DOT

250cc

Print Area

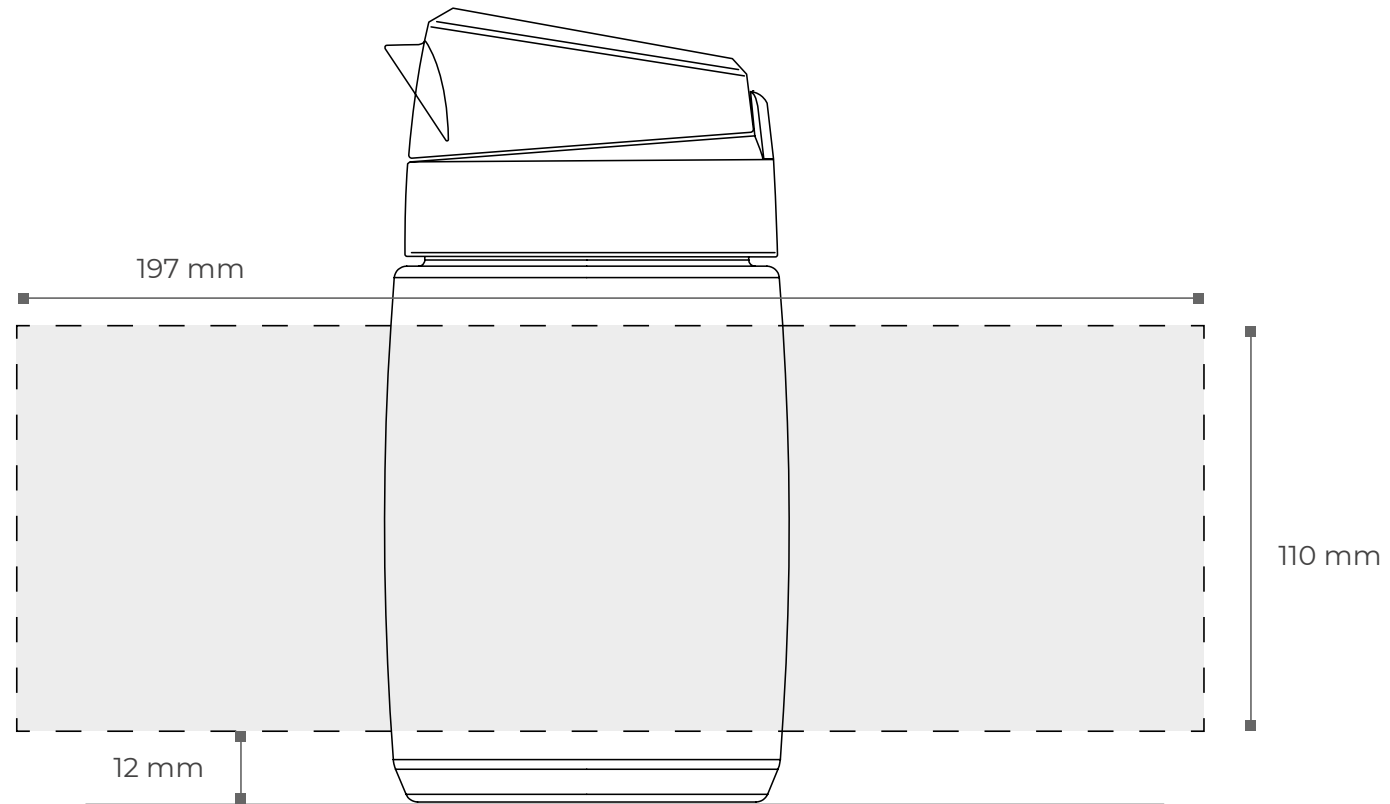
*The impression can not close on the circumference of the bottle:
it's necessary to consider a non-printable area (approx. 0,8 cm width)*
